CCU 1 - Digital Clock & VOR1/2 Modification

April 16 2004

The modification for the Digital Clock

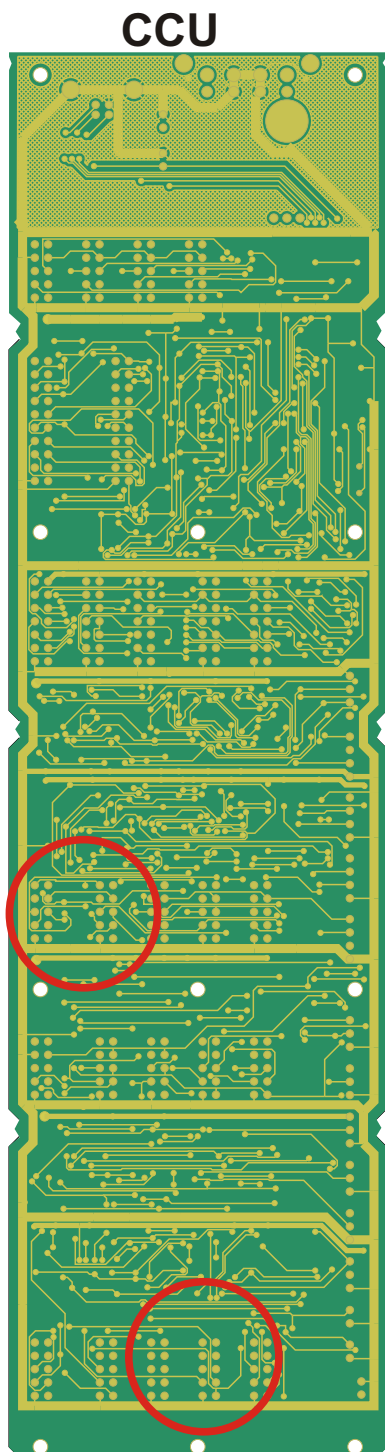
Step 1: cut the trace on the back of the board as indicated by the black stripe in picture "Step 1" in order to free pin 2 of CN 14. Use a sharp knife. Be very carefull not to damage any other traces!

Step 2: solder 2 new wires in place as shown on the picture "Step 2".

The modification for the VOR1 and VOR2

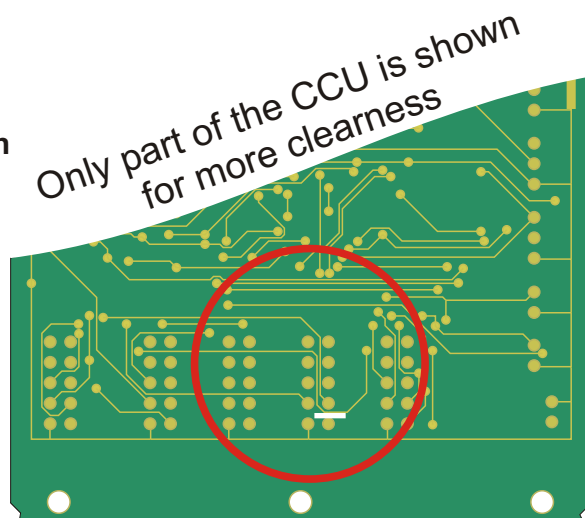
This requires only the soldering of 2 wires on the back side of connector C26 and CN27 between pin 1 and pin 10 as shown on the drawing below.
